**BOARD OF ZONING ADJUSTMENT
STAFF REPORT****Date: April 7, 2014****CASE NUMBER**

5889

VARIANCE REQUEST

SITE PLAN

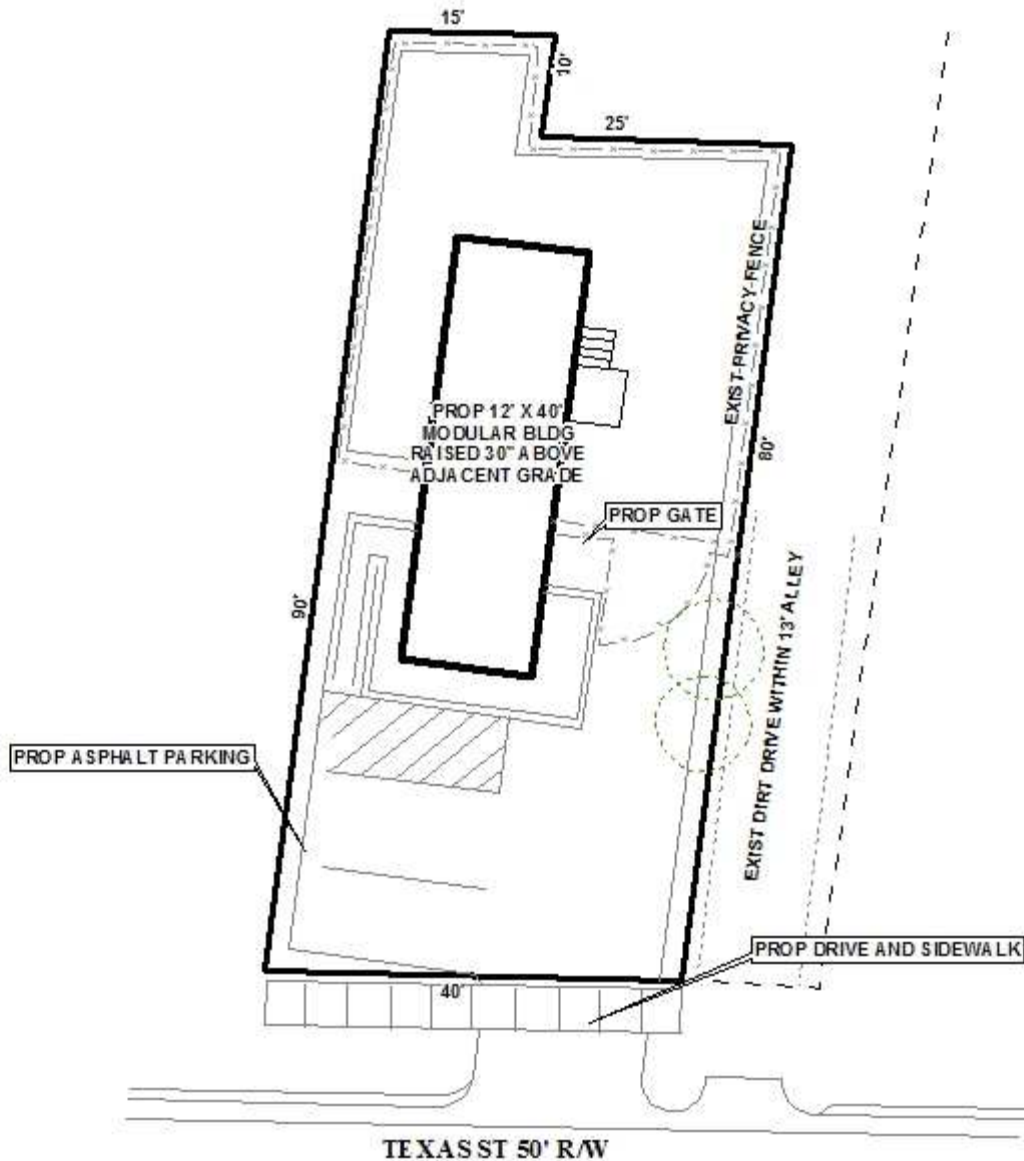
It is recommended that the access for the existing alley should be separated from the access to the subject property.

The proposed plan shows that the proposed curb cut will be constructed in front of adjacent properties to the East and West; therefore, if approved, the applicant would be required to submit a letter along with the Right-of-Way permit application, from the adjacent property owners, that allows the applicant to place a portion of the proposed driveway curb-cut in front of their property (City of Mobile Right-of-Way Construction and Administration Ordinance, Section 57-124).

Backing into the right-of-way is not desirable, especially in this location given the transition in the roadway alignment of Texas Street. The continuous curb cut across the front of the property and the alley may give a false impression that the alley has been incorporated into the subject property and is no longer public right-of-way. Driveway improvements cannot extend beyond the property line without the consent of the adjacent property owner. As illustrated on the site plan, it would apply to the property owner on the east side of the alley, as well as the adjacent property owner to the west.

The proposed aisle width may not be adequate for pick-up trucks to back out of the parking spaces (especially from the handicap space), as the aisle width for backing decreases to 11'. The applicant is proposing a 7' aisle adjacent to a 9' parking space. This will provide a total width of 16' for van accessibility which meets ADA requirements.

As proposed, the applicant appears to be overdeveloping the site, as evidenced by the numerous variance requests. Additionally, only frontage trees are required in I-1 districts, thus the applicant is only required to provide 1 frontage tree in order to be in compliance.

The property, located in an I-1, Light Industry district, abuts residences at the Northwest corner of the property. Amendments to Section 64-4.D.1. of the Zoning Ordinance in 2012 require that commercial uses next to residential uses (even when in the same zoning district) must provide a 10-foot protection buffer: the site plan depicts a more than adequate buffer, and in fact the buffer depicted on the site plan could be reduced, which would allow the proposed modular building to be placed further North and West on the site. By moving the location of the modular building, additional area for parking and the proposed driveway would be available. It appears, in fact, that a redesign to allow two parking spaces on-site, facing West, would thus allow a 22 ± foot wide driveway and eliminate the backing into Texas Street. This redesign would also provide enough room to allow sufficient landscape area to plant one overstory tree, and provide some level of landscape area compliance.

Regarding #1, the Zoning Ordinance does not regulate accessible parking spaces. The International Building Code references American National Standards Institute (ANSI) 117.1, which defines accessible parking space width and accessible access aisle width requirements. Generally, the first parking space at any location must be "van accessible," and thus the parking space plus adjacent striped access aisle must be a combined total of 16 feet (thus a 9 foot wide parking space plus a 7 foot wide aisle does appear to comply).

Regarding #2, only two on-site parking spaces are provided, and the anticipated traffic volume for this site is not expected to be high.

Regarding # 3, a vehicular access width of 11 feet to the rear of the property, given the limited depth and the inability to turn around, while not ideal, would be sufficient.

And finally, regarding #4, the applicant states that they will exceed the total site landscaping requirement by providing 466 square feet, rather than the minimum of 402 square feet. The applicant will not be able meet the 241 square foot frontage landscaping requirement, and is only proposing 128 square feet. Given the fact that the overall site will exceed the minimum requirements, it would seem reasonable to compromise the frontage requirement.
